APPLICATION FOR SUBMITTAL OF POST-APPROVAL DOCUMENT

VCCCD - #4 OUTDOOR WORKOUT - AEC
 Campus Student Center
 4667 Telegraph Road
 Ventura, CA 93003

50% CONSTRUCTION DOCUMENTS 2022-10-04
 100% CONSTRUCTION DOCUMENTS 2022-10-17
 DSA SUBMITTAL 2022-12-07
 06/02/23 Revision 2

FLOOR PLAN DETAIL

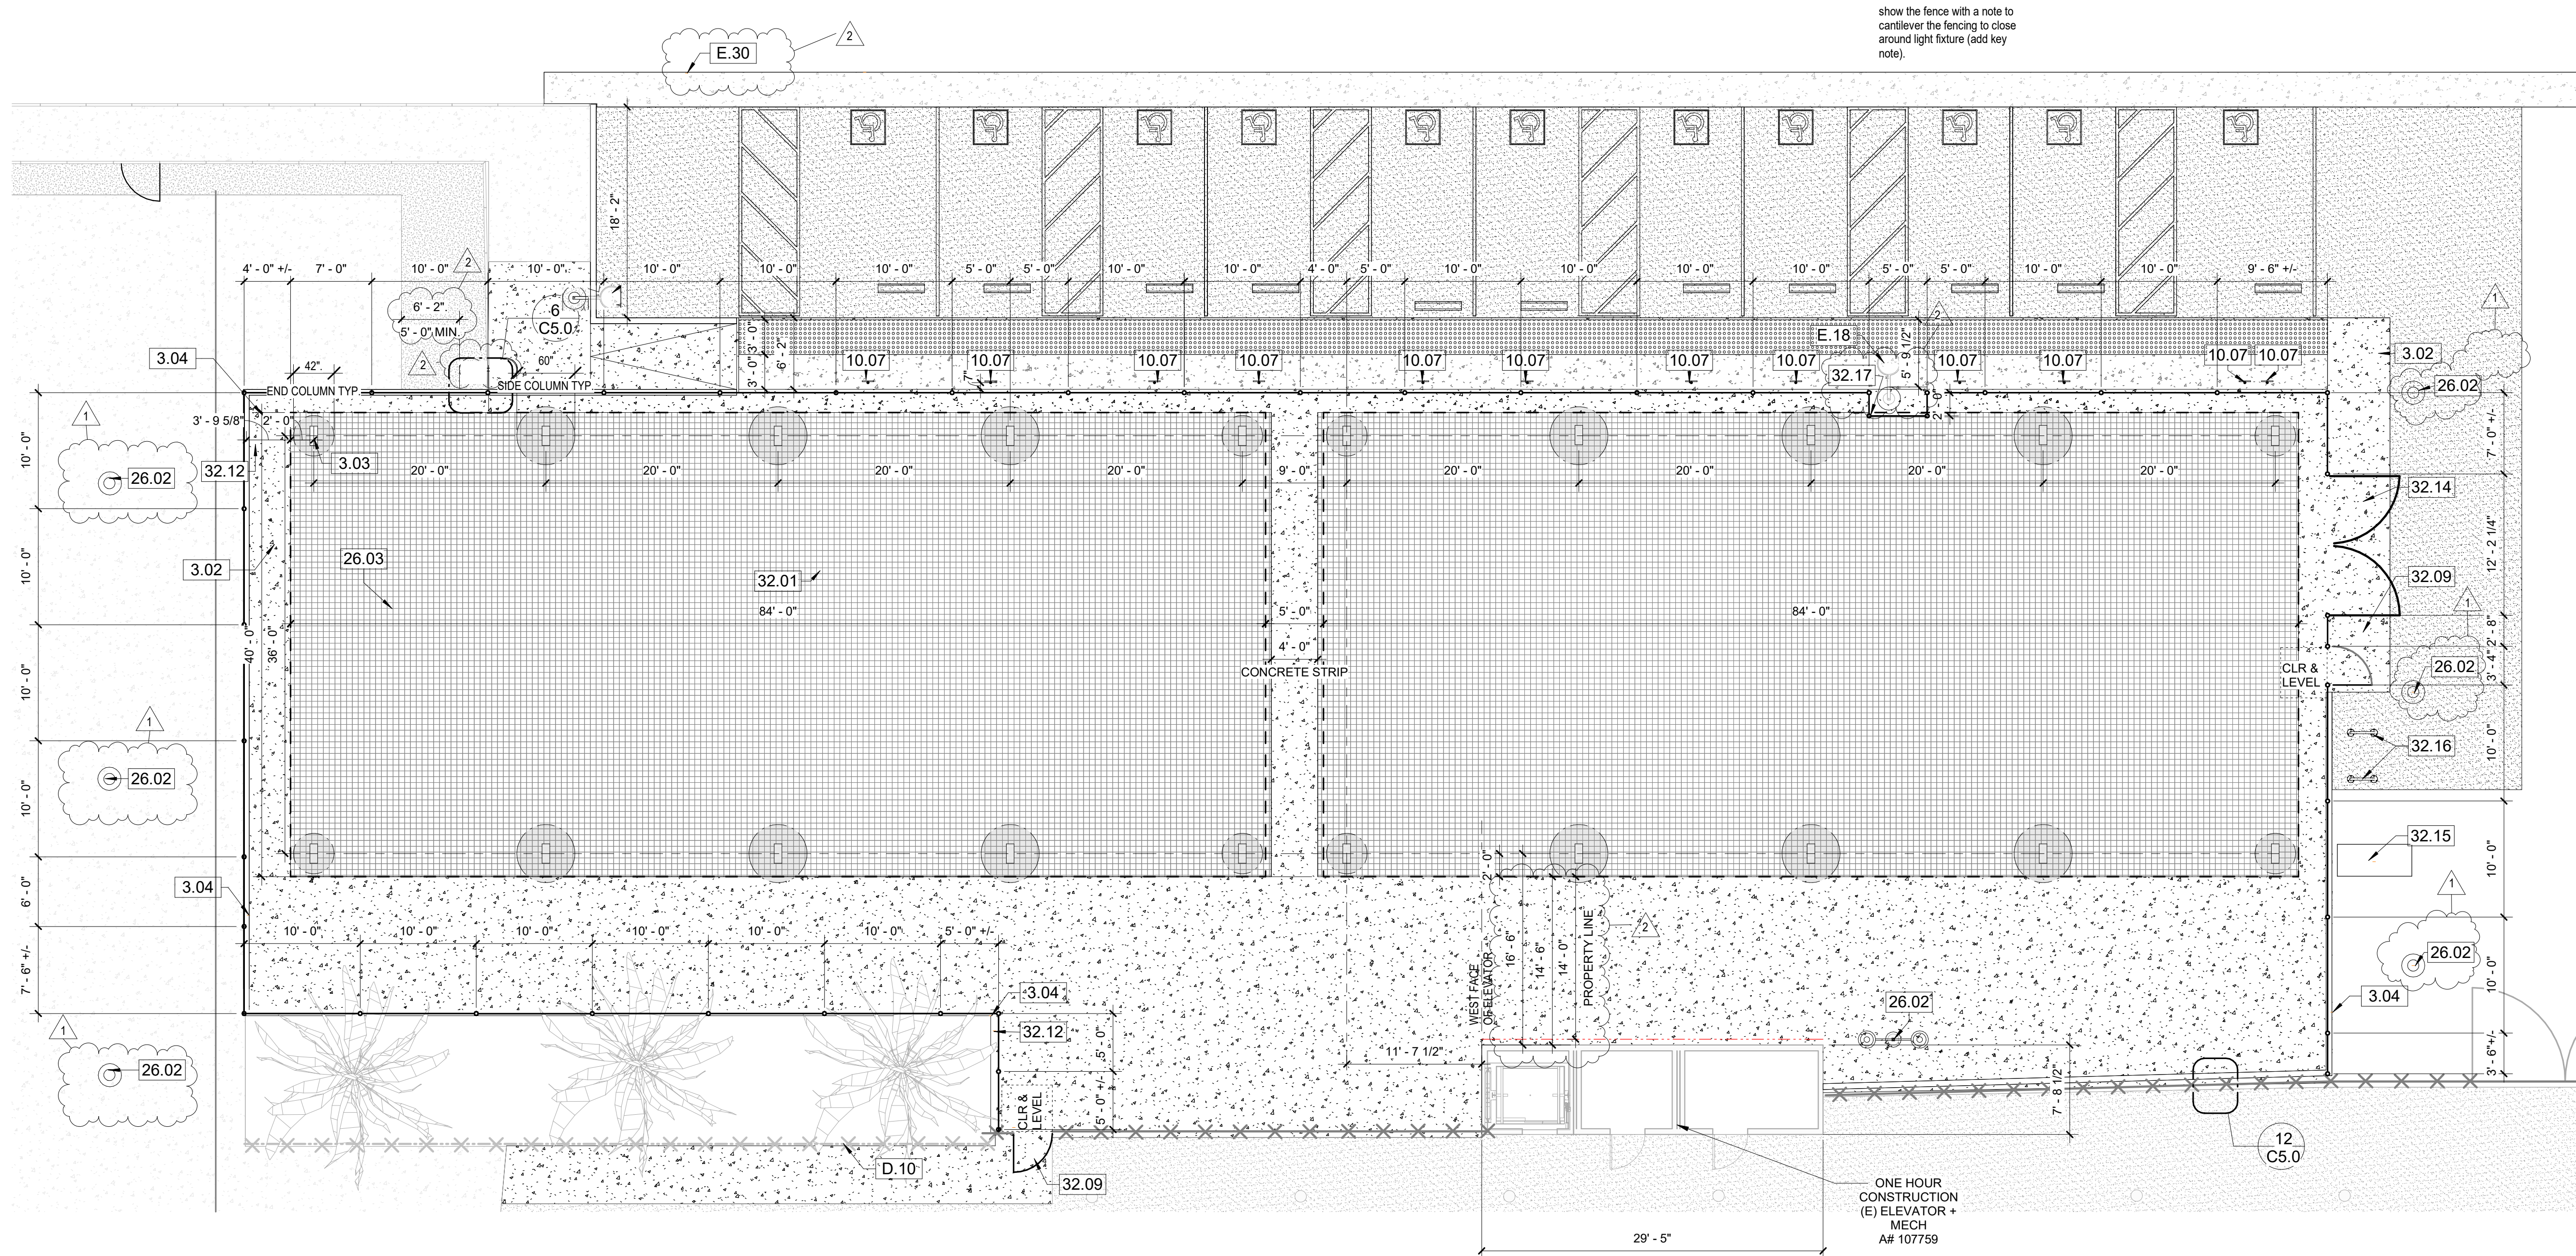
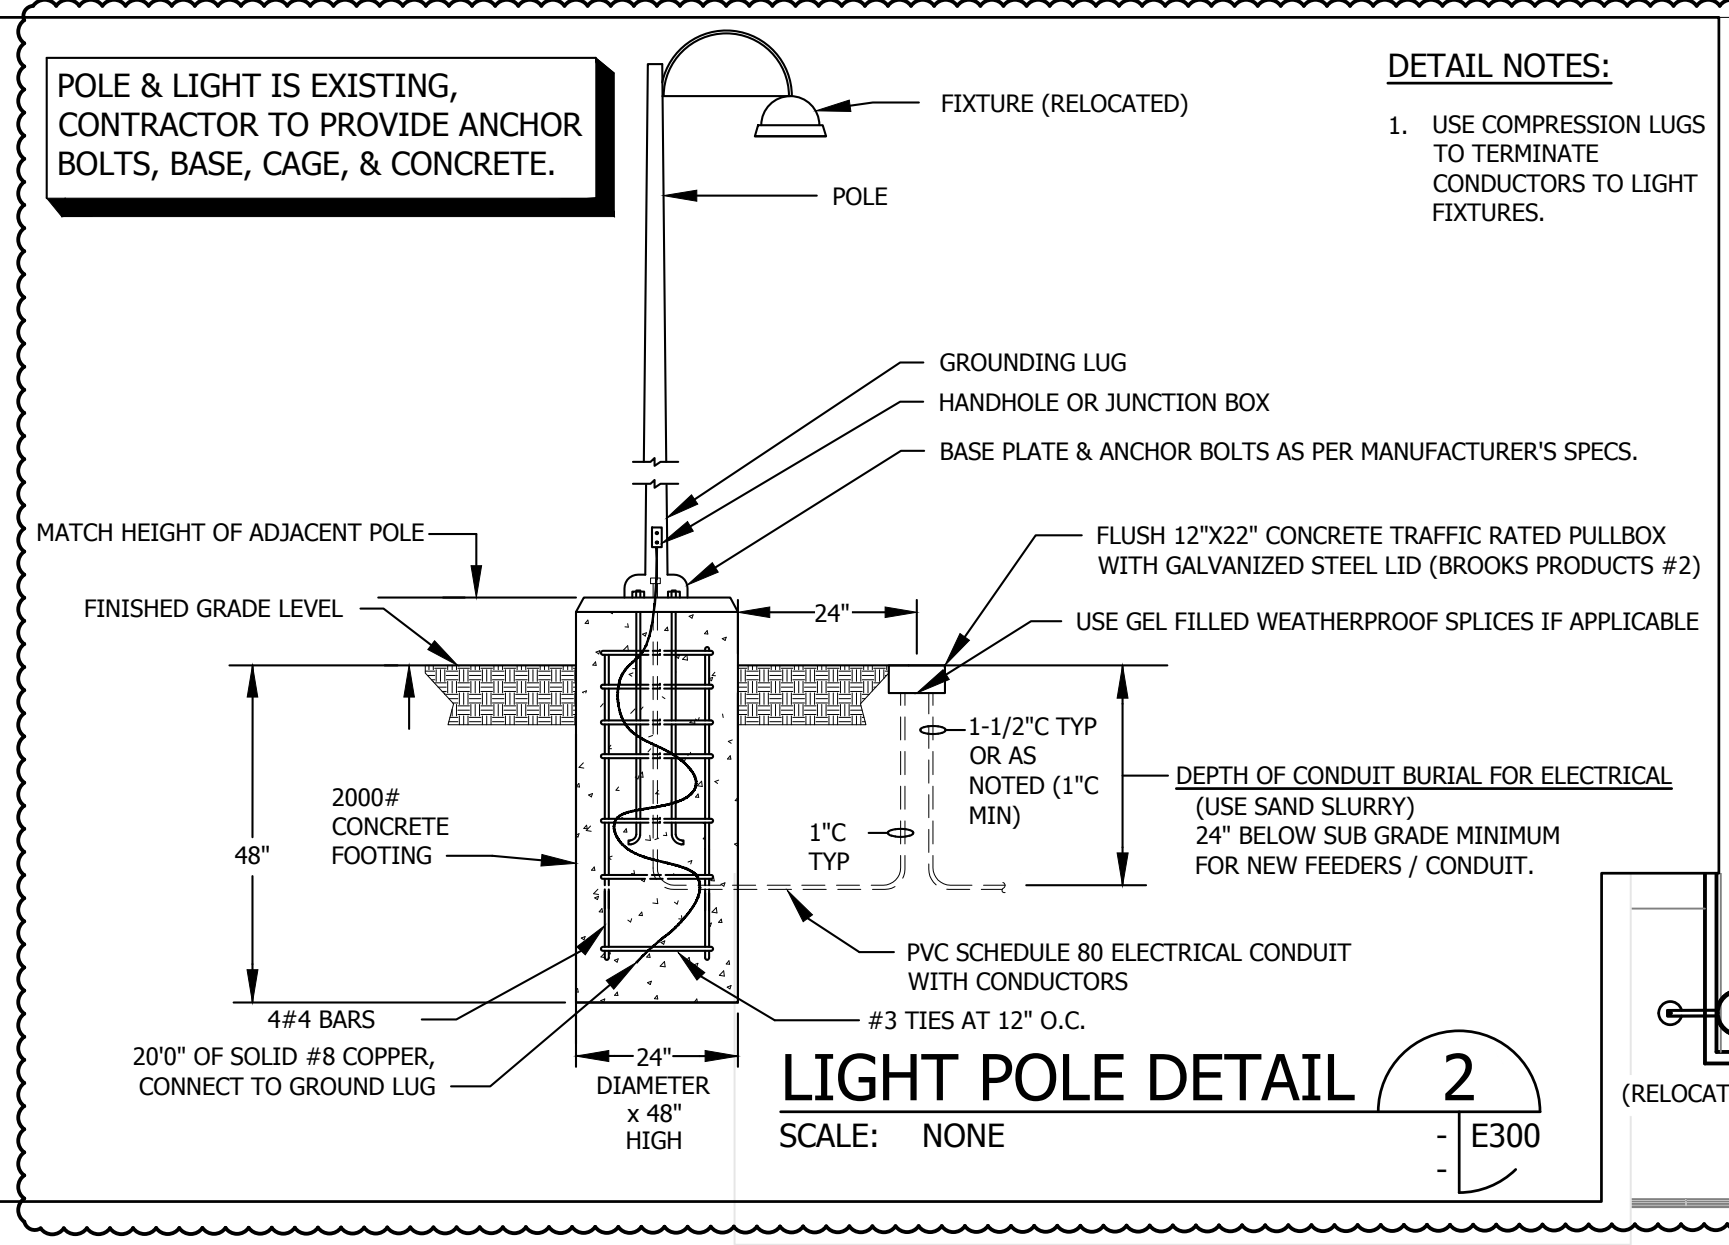
show the fence with a note to cantilever the fencing to close around light fixture (add key note).

- 32.16 (N) BICYCLE U RACK W/ CROSS BAR MODEL, STANDARD: BLACK PLASTISOL, SURFACE MOUNT
- 32.17 CANTILEVER THE FENCING TO CLOSE AROUND LIGHT FIXTURE.
